**DOCUMENT 00 90 01
ADDENDUM #2**

Project: Provo City Airport Pump Station PROVOENG202320542

Date: Tuesday, November 23, 2022
Bid Date: Thursday, December 15, 2022
Bid Time: 10:00 a.m.

PROVO CITY
PROVO AIRPORT PUMP STATION
WET WELL PLAN & SECTIONS

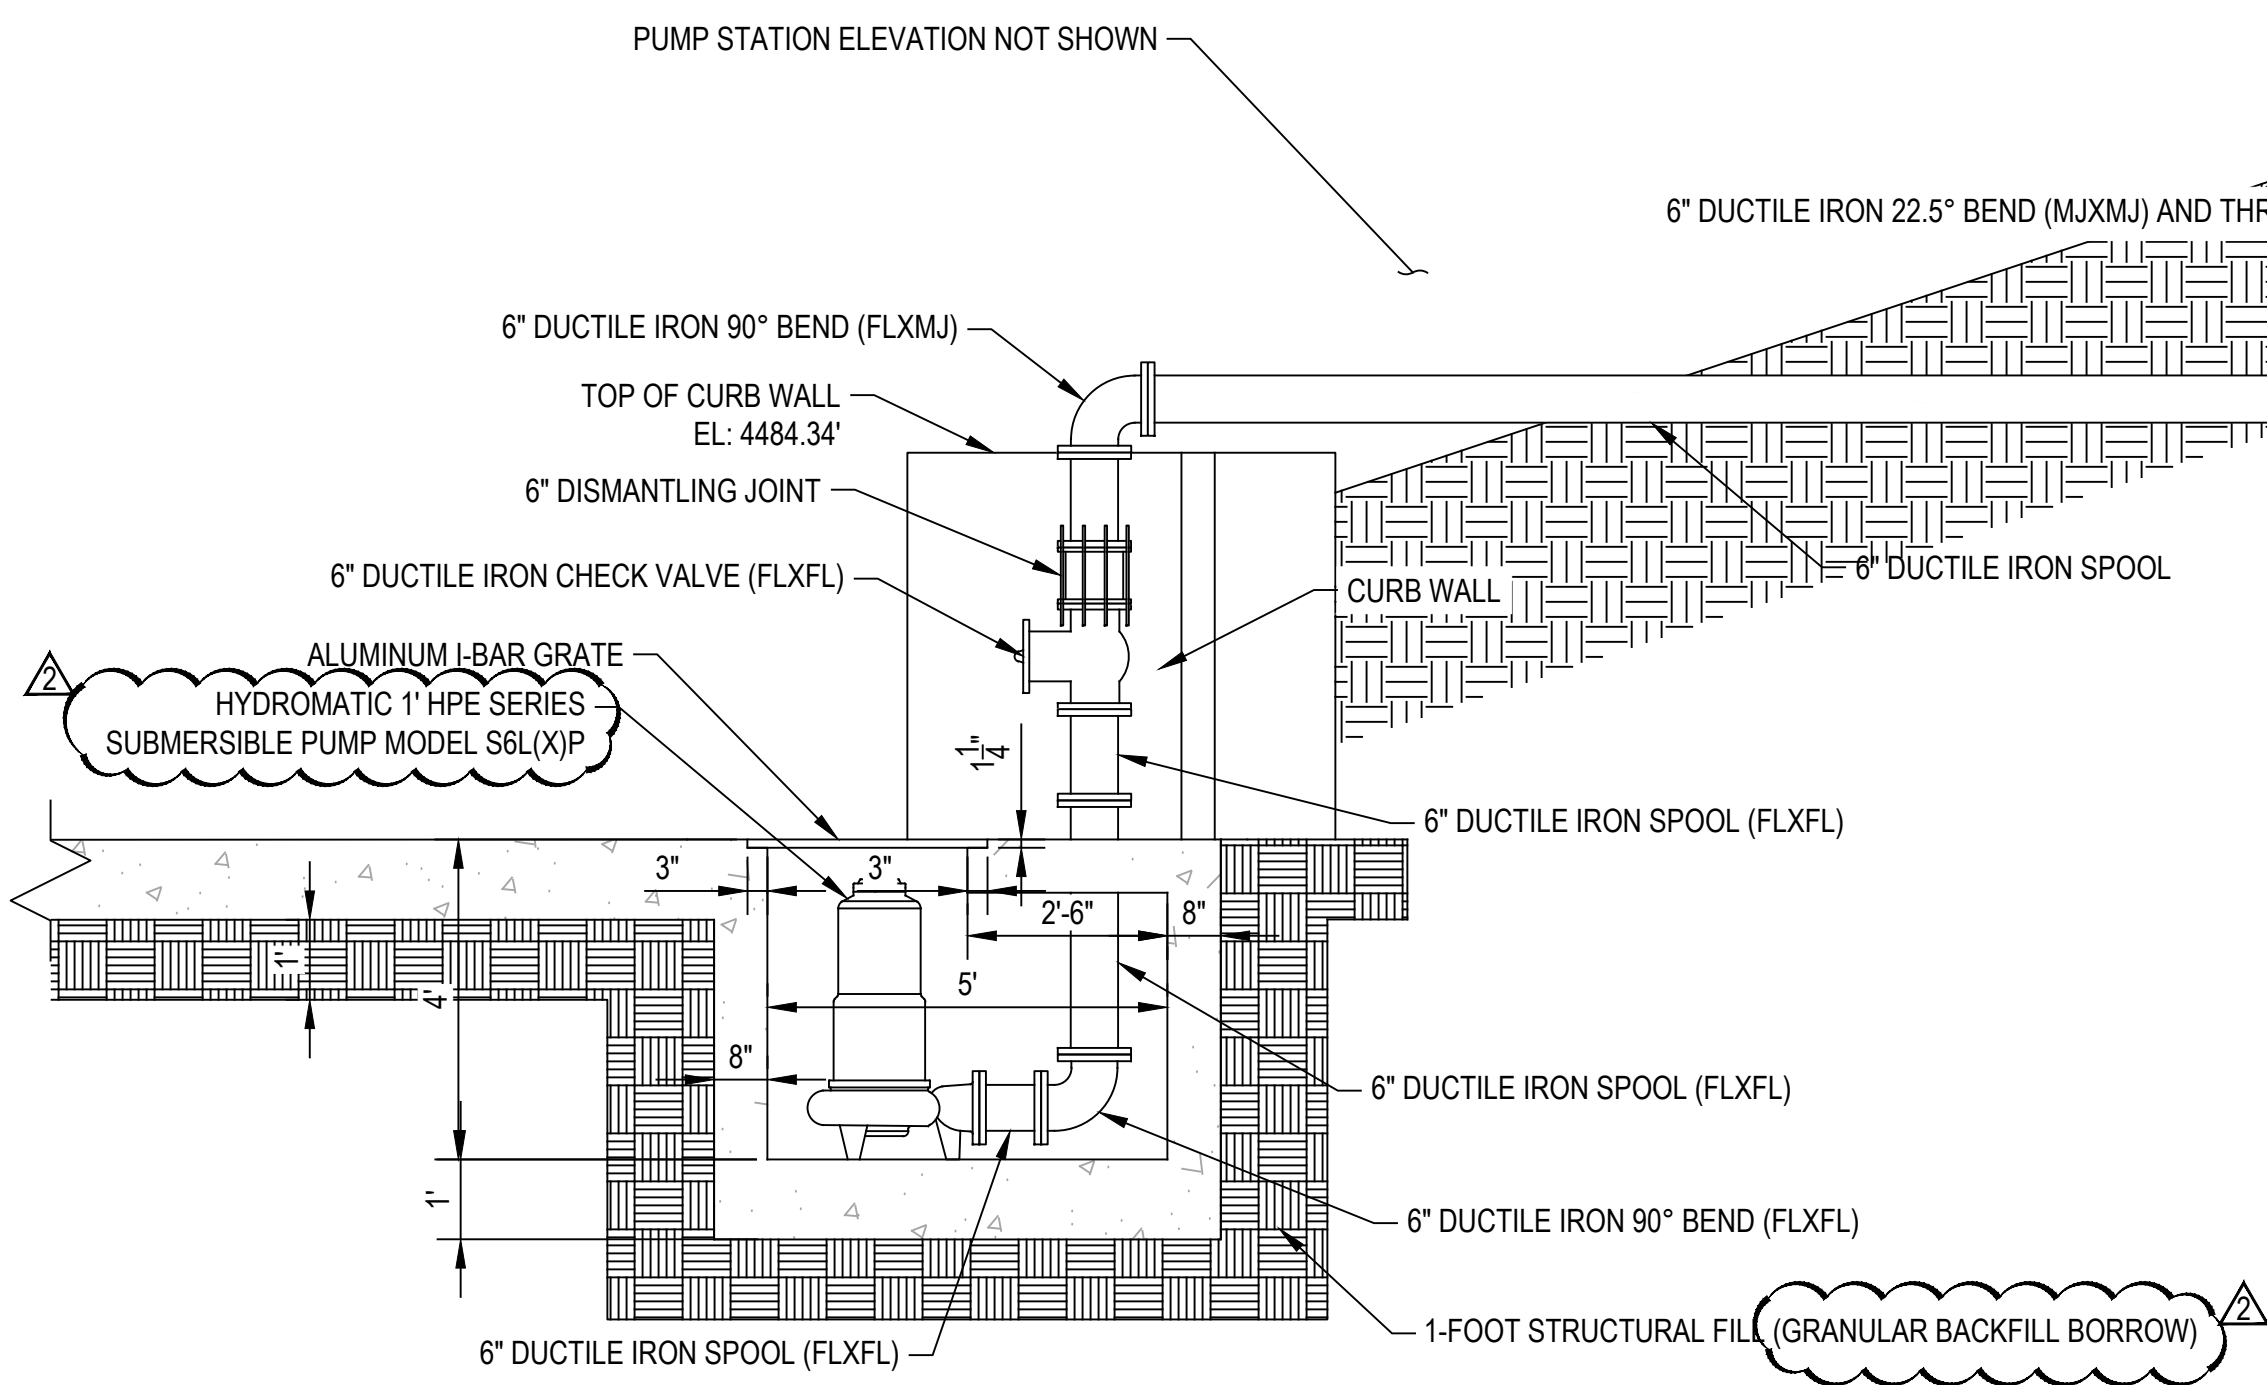
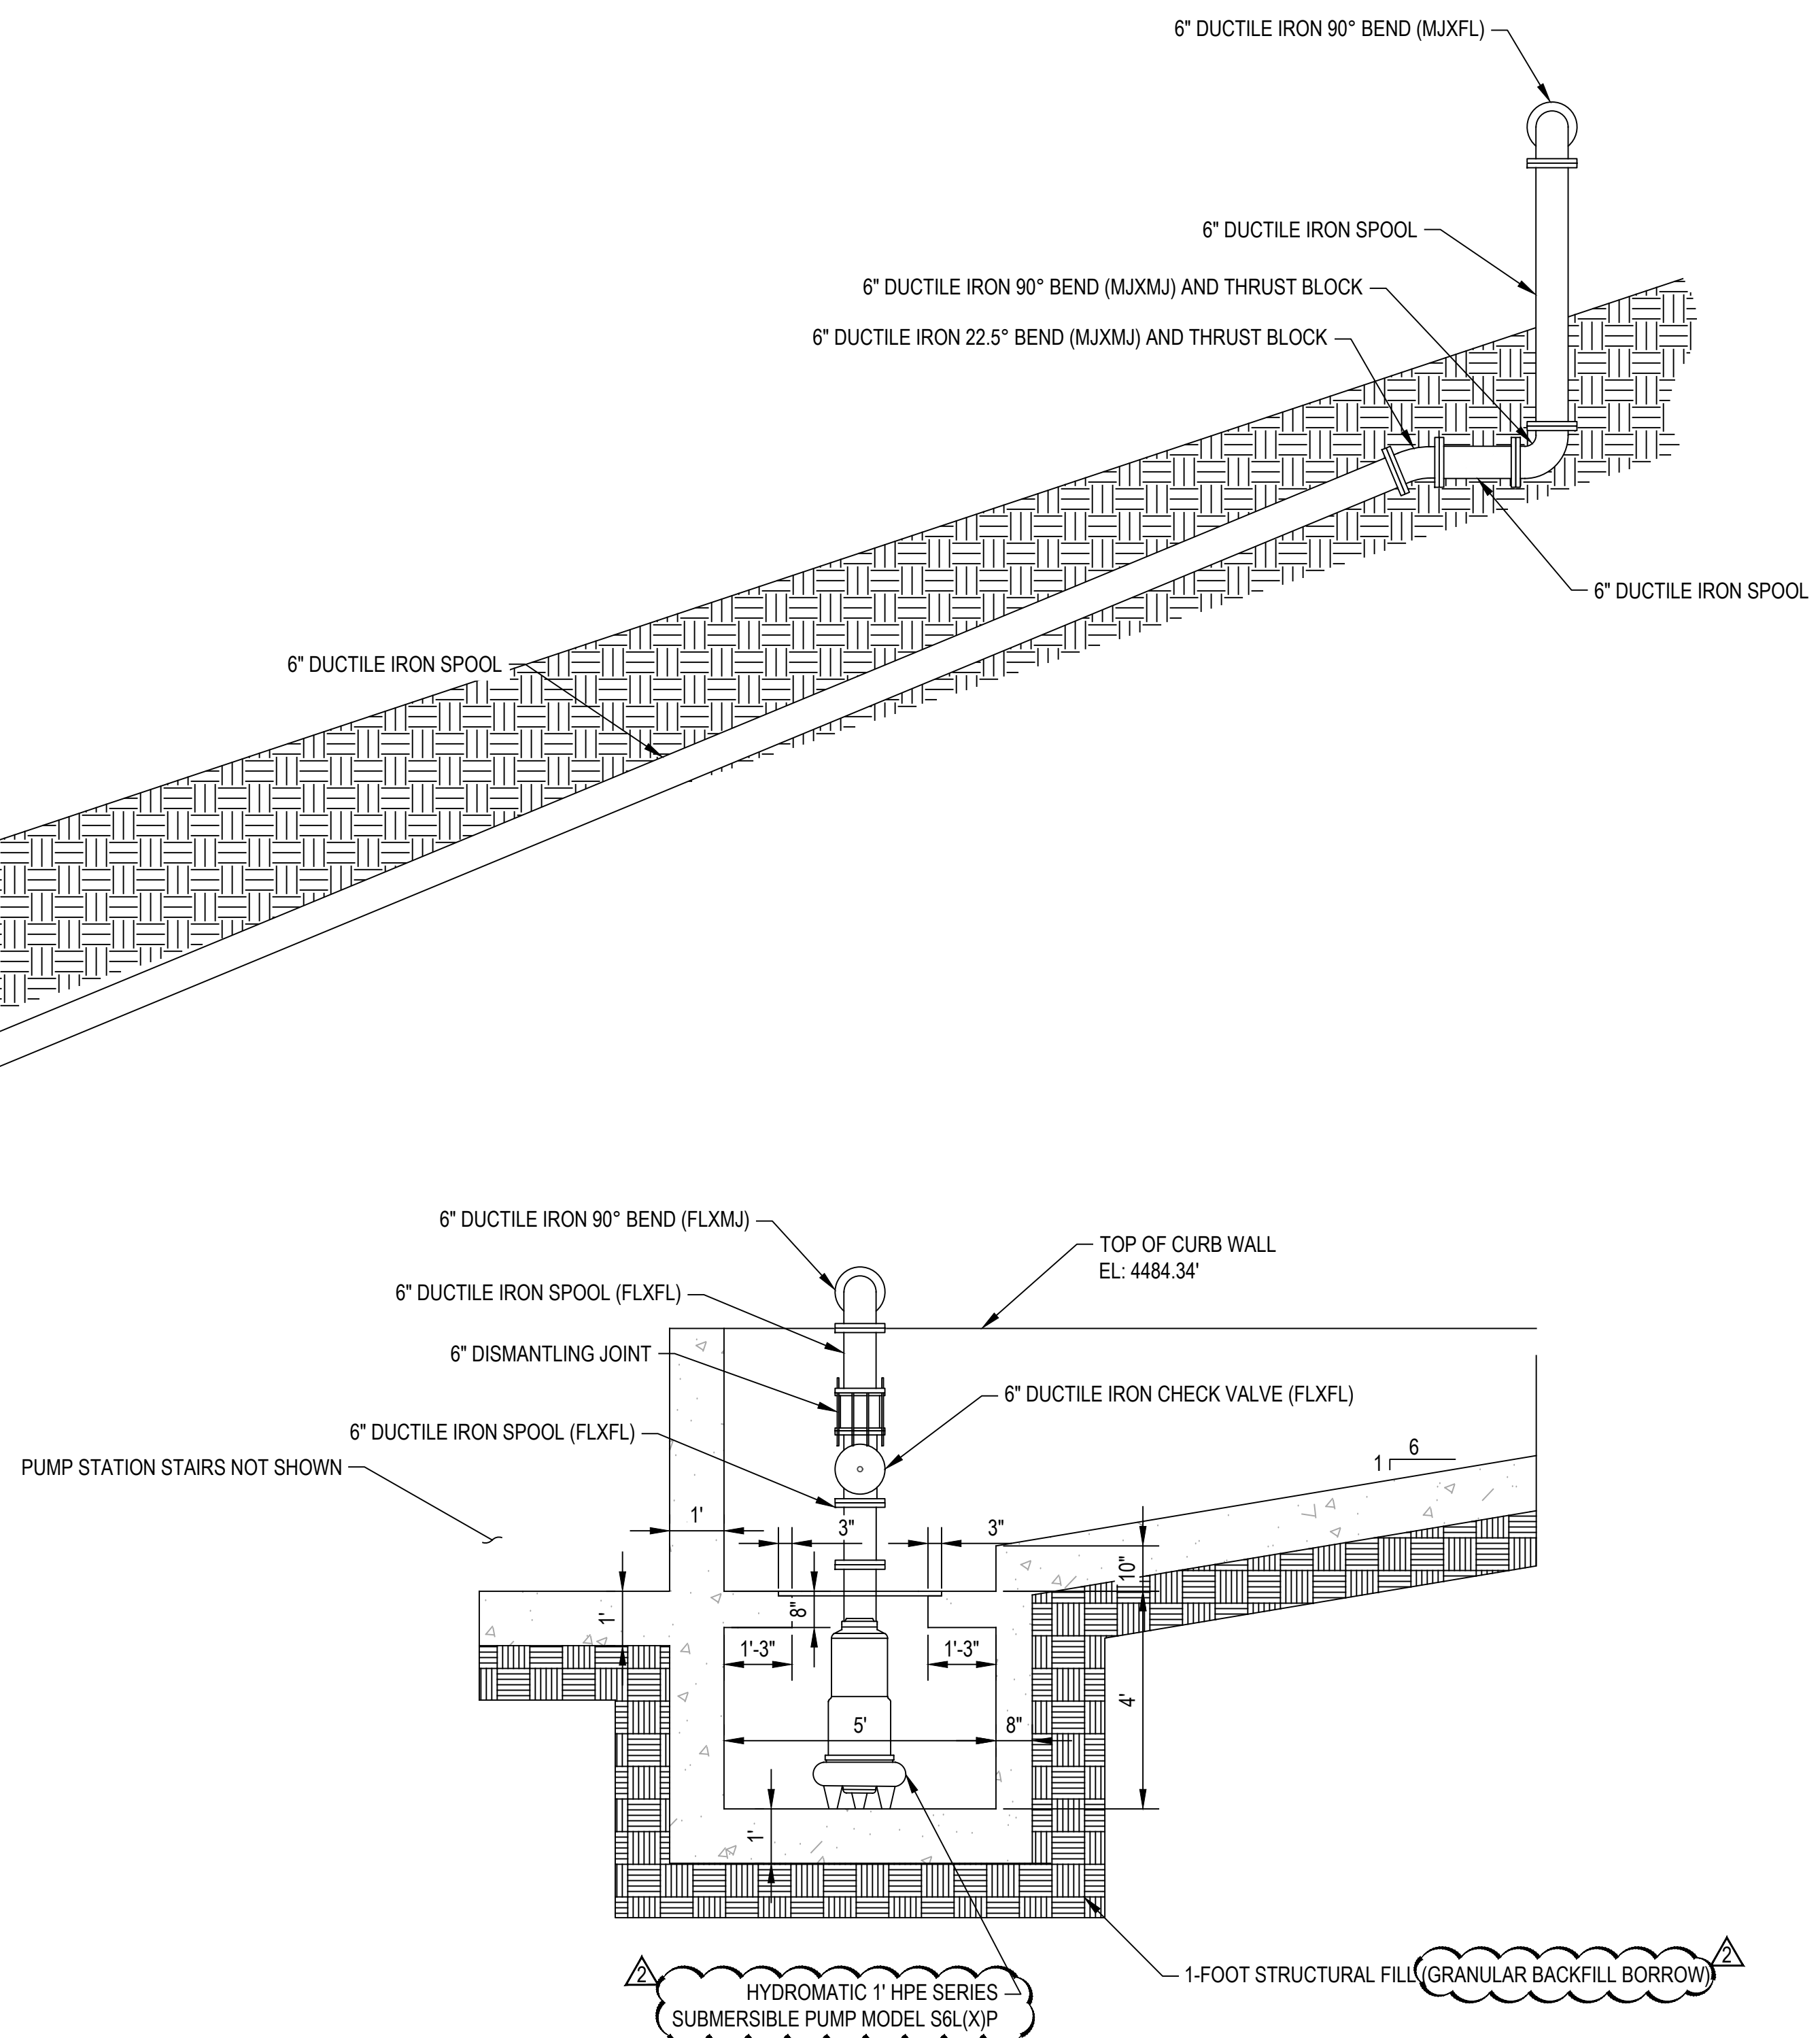
Delete and replace this sheet. The model of the pump has been corrected and structural fill references granular backfill borrow.

SUMP BASIN FOUNDATION
 1 S101 SCALE: 3" = 1'-0"

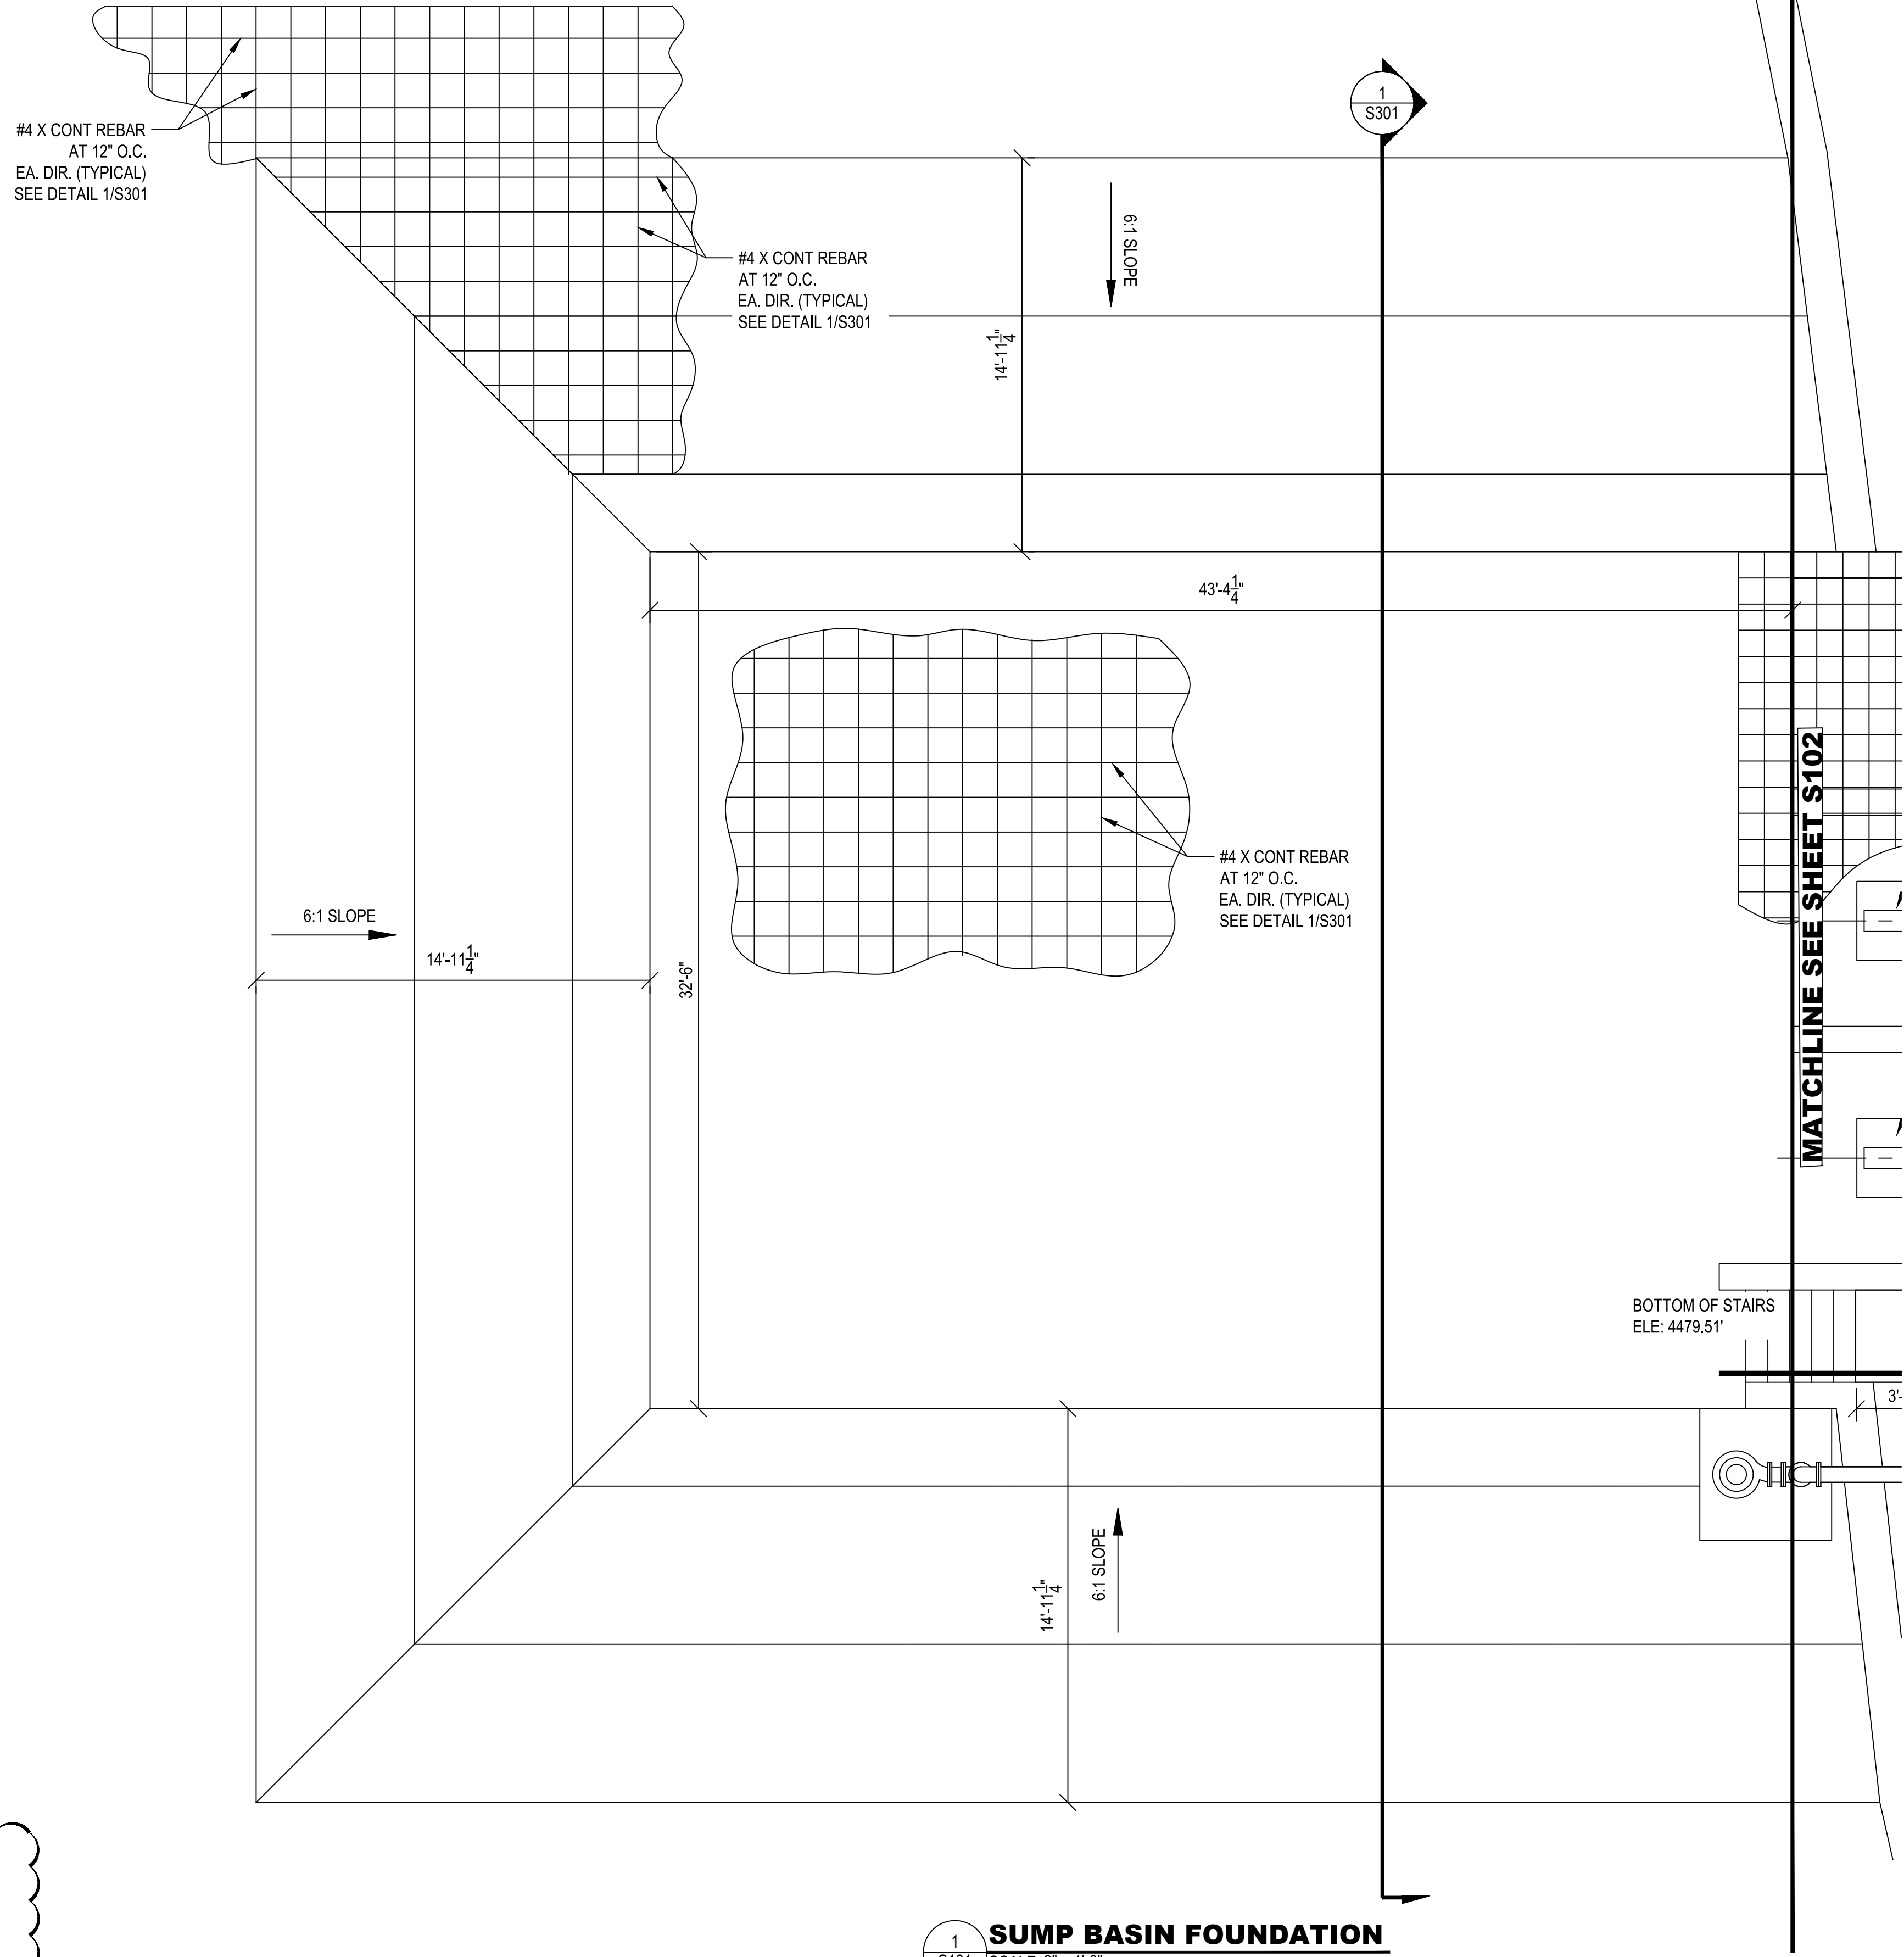
Delete and replace this sheet. The sheet now includes notes on the construction joints and the construction expansion joints.

- NOTES:
1. PLACE FORMED EXPANSION JOINTS AT INTERFACE BETWEEN SLAB AND WALL AND AT APPROXIMATELY 50-FOOT INCREMENTS PERPENDICULAR TO SLAB EDGES.
 2. EXPANSION JOINTS ARE TO BE CREATED USING 1/2" THICK NEOPRENE MATERIAL PLACED TO FULL SLAB DEPTH.
 3. PLACE SAW CUT CONTROL JOINTS EVENLY ACROSS SLAB IN EACH DIRECTION AT A MAXIMUM SPACING OF 15 FEET ON CENTER.

SECTION THROUGH SUMP BASIN
SCALE: 3/8"=1'-0"

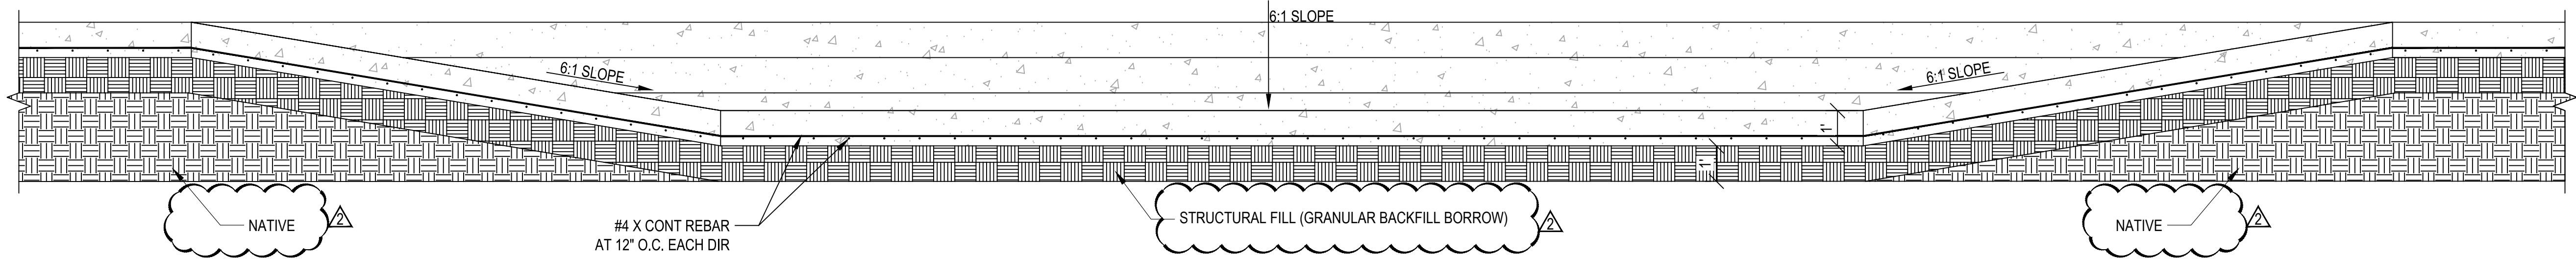
Delete and replace this sheet. Clarification on the depth of the structural fill (granular backfill borrow) under the concrete.
